ADDENDUM NO. 1

FOR: MIDDLE SCHOOL PARKING LOT IMPROVEMENTS
(LEWIS CENTRAL MIDDLE SCHOOL)

JOB NO. 0124284.01-020

DATE: February 23, 2026

UTILITY PLAN

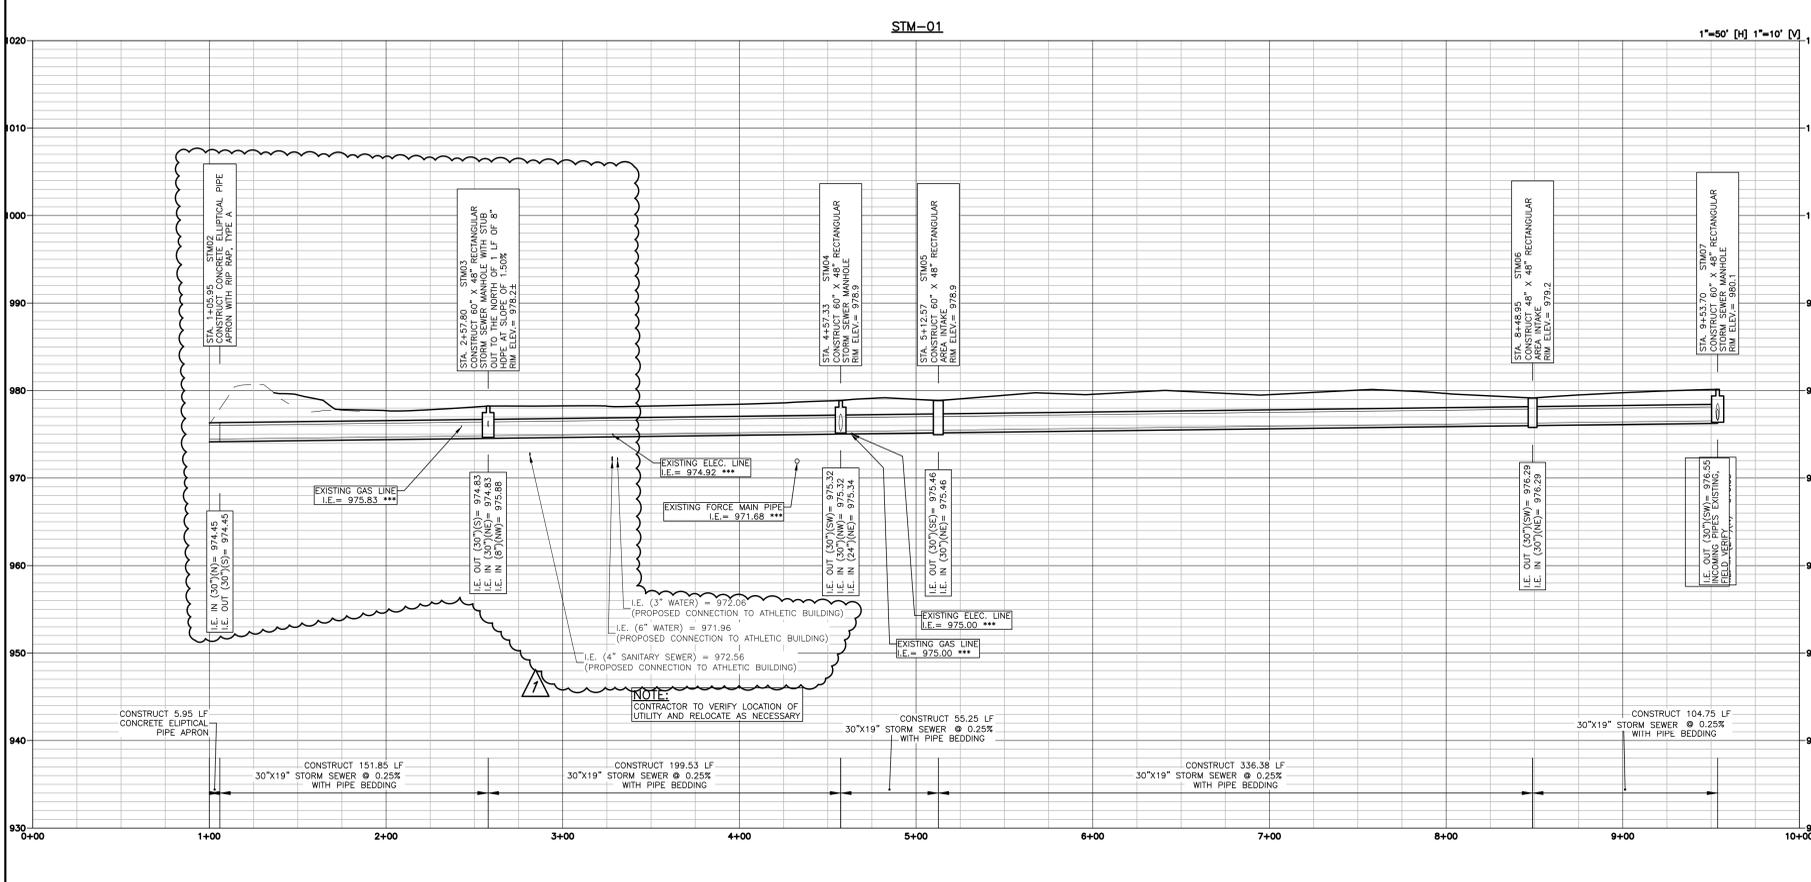
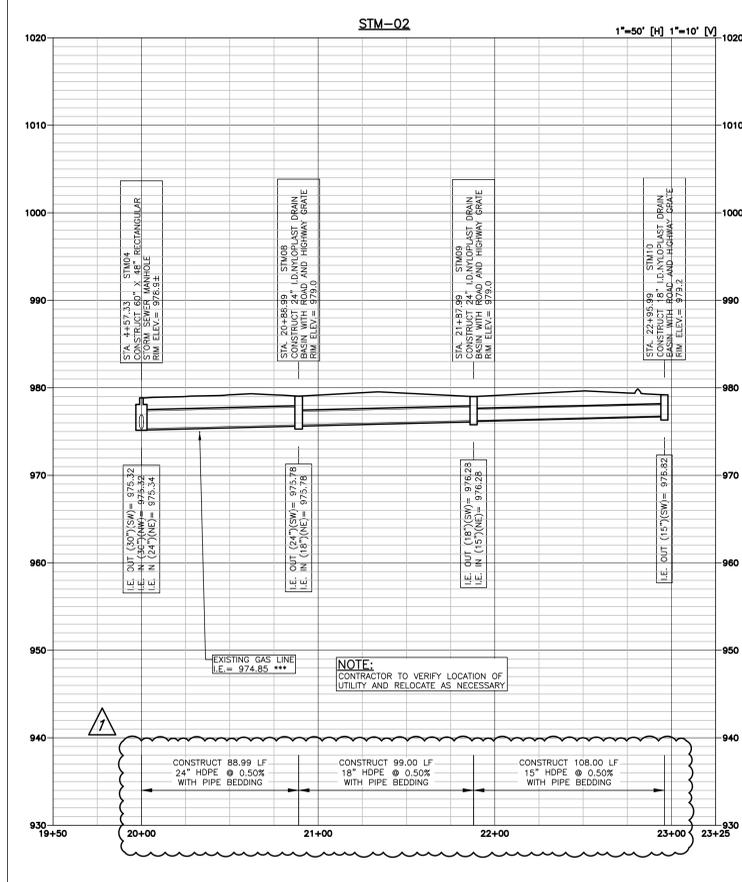
- ADDED PROPOSED ATHLETIC BUILDING SANITARY, STORM SEWER, AND WATER CONNECTIONS
- ATHLETIC BUILDING FFEs UPDATED
- ADDED PROPOSED RIP RMP

ENLARGED PAVING PLAN - 1 OF 2

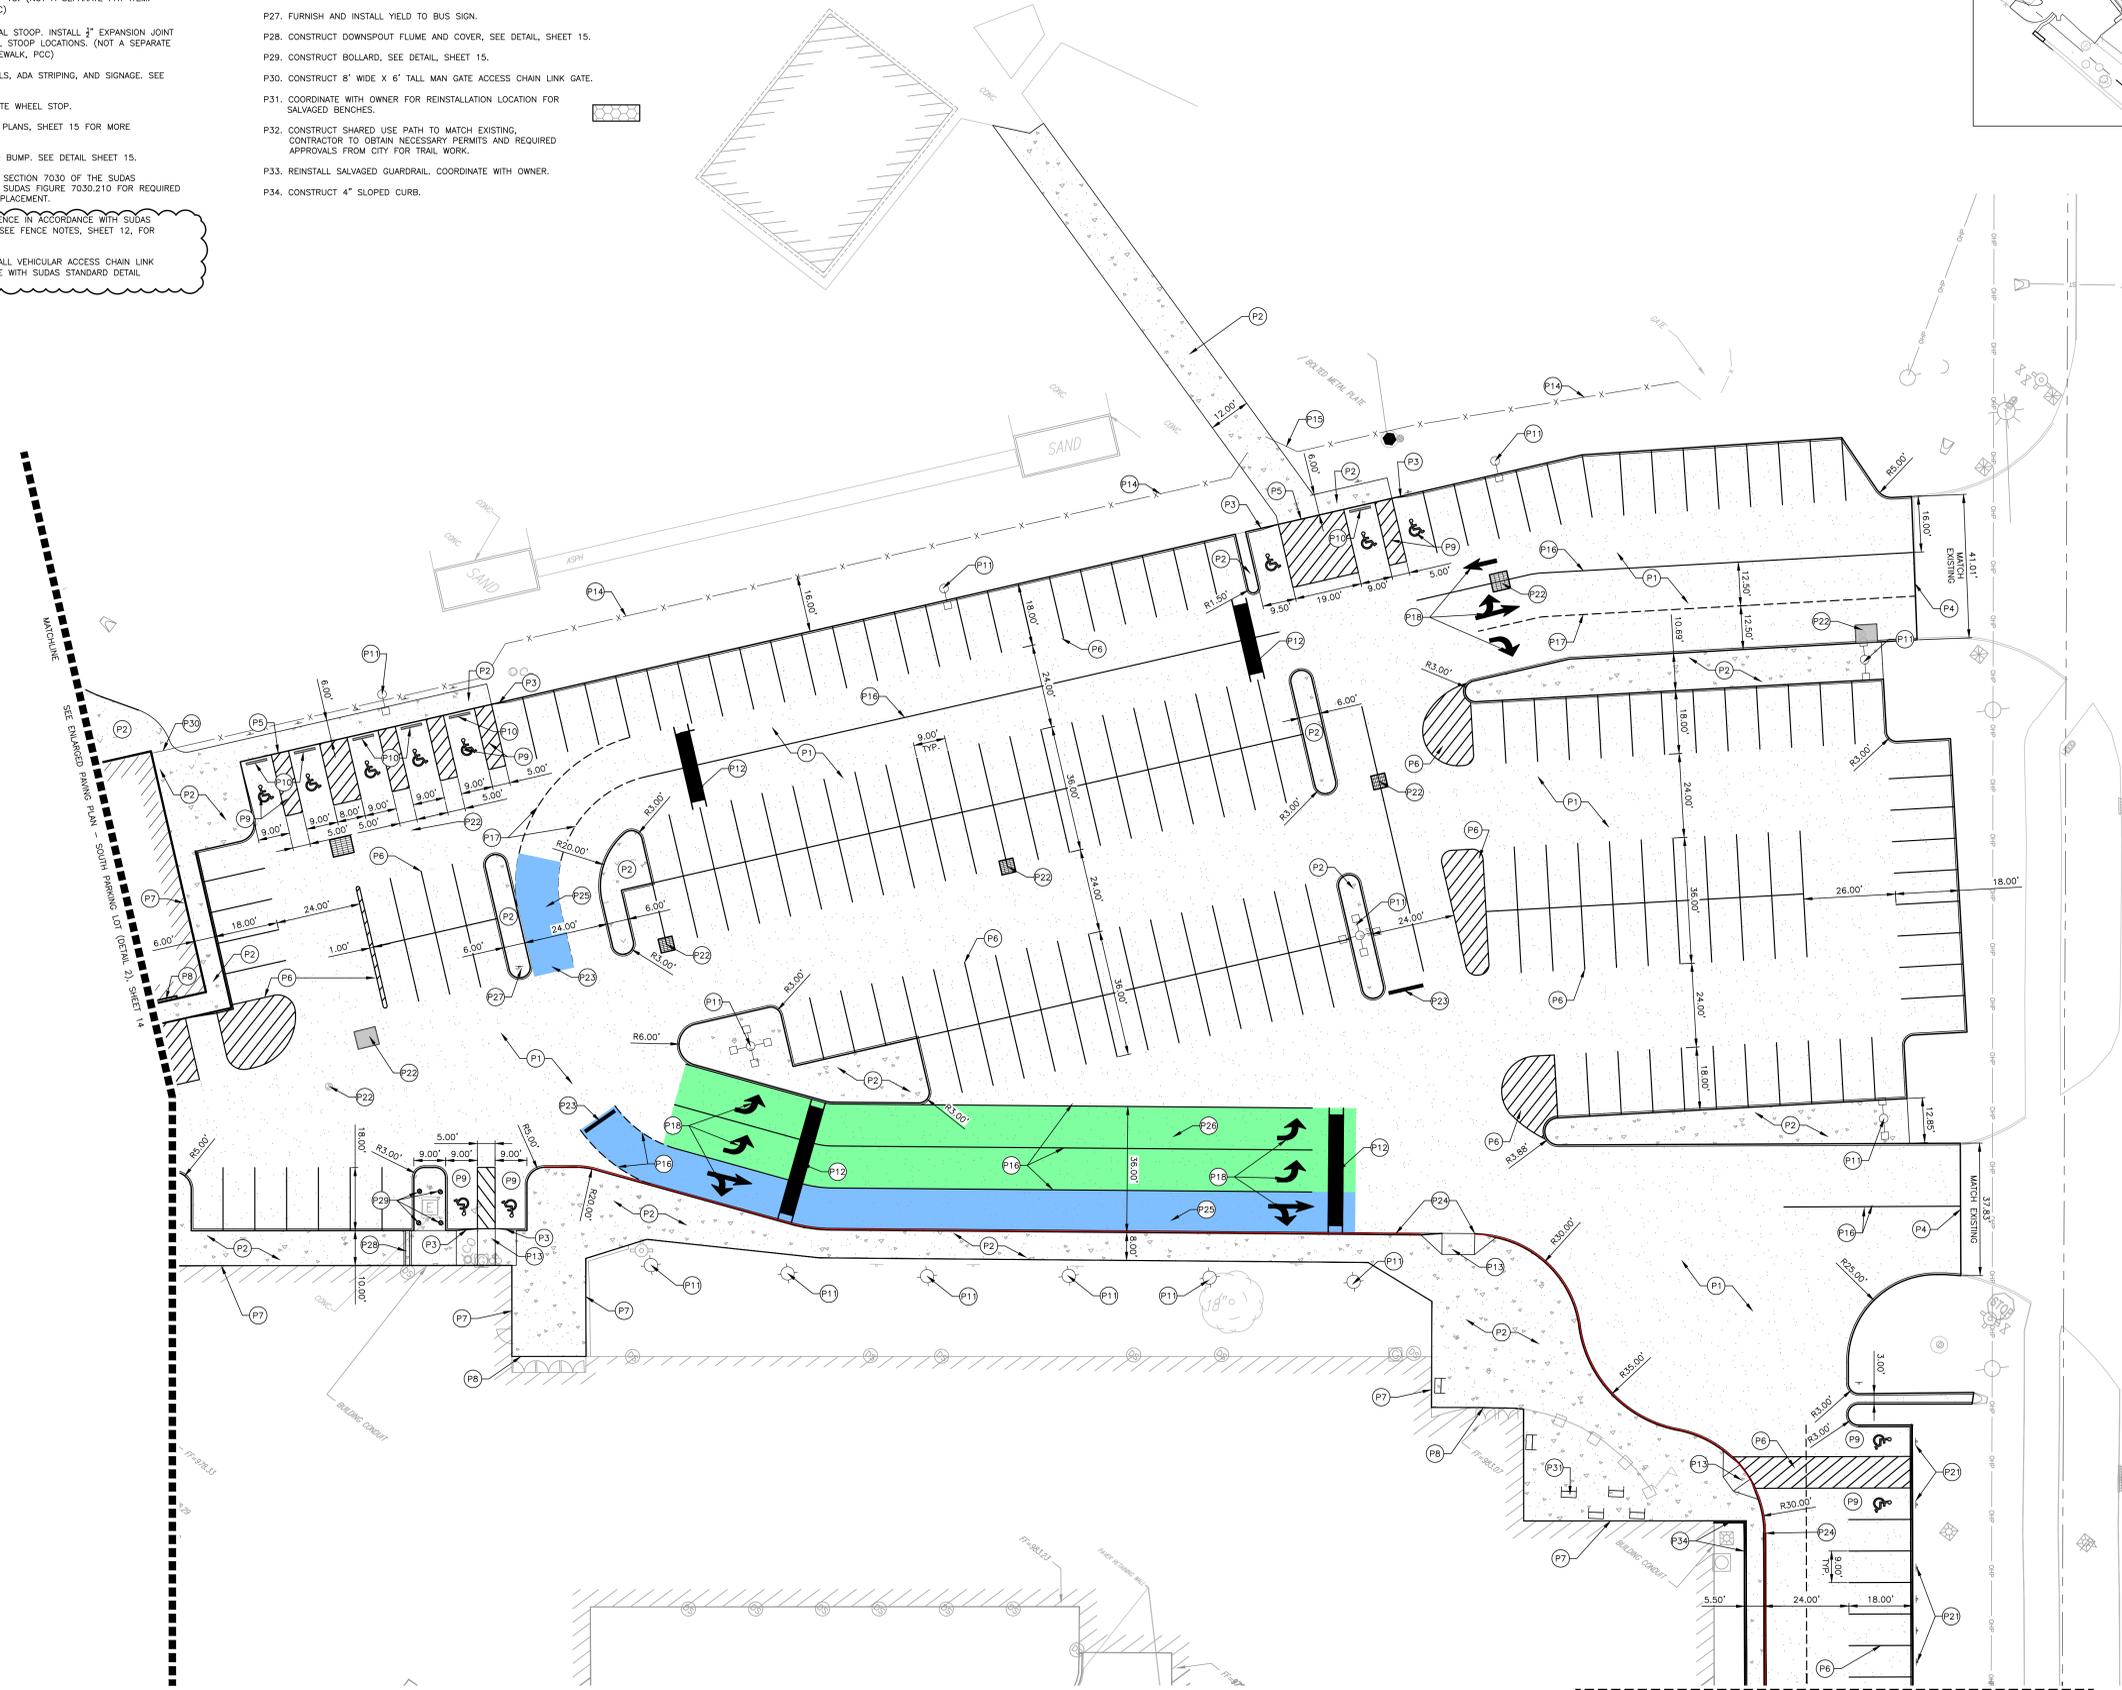
ADDENDUM 1 - 02-23-2026
- UPDATED FENCE AND GATE NOTES

P14. CONSTRUCT 6" CHAIN LINK FENCE IN ACCORDANCE WITH SUDAS STANDARD DETAIL 9060.101. SEE FENCE NOTES, SHEET 12, FOR DETAILS.

ENLARGED PAVING PLAN - 2 OF 2

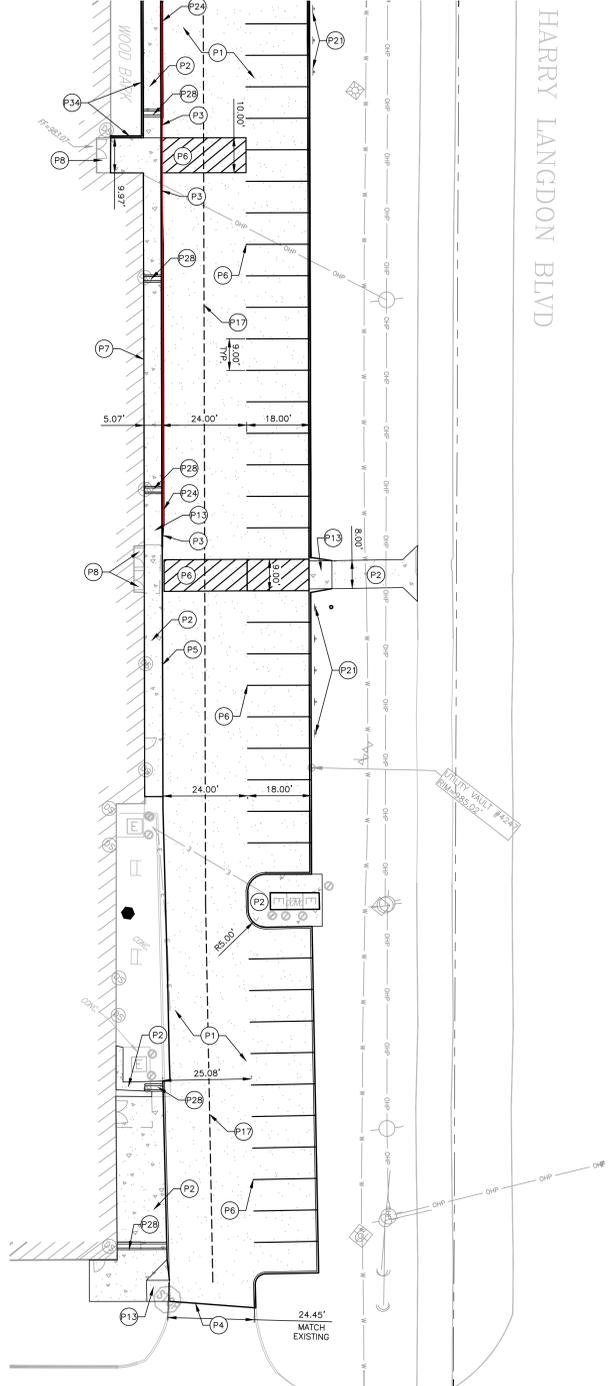
ADDENDUM 1 - 02-23-2026
 - UPDATED FENCE AND GATE NOTES
 - REMOVED SEGMENTAL RETAINING WALL
 - ADDED BOLLARDS AT EXISTING UTILITY
 VAULT NEAR ATHLETIC BUILDING
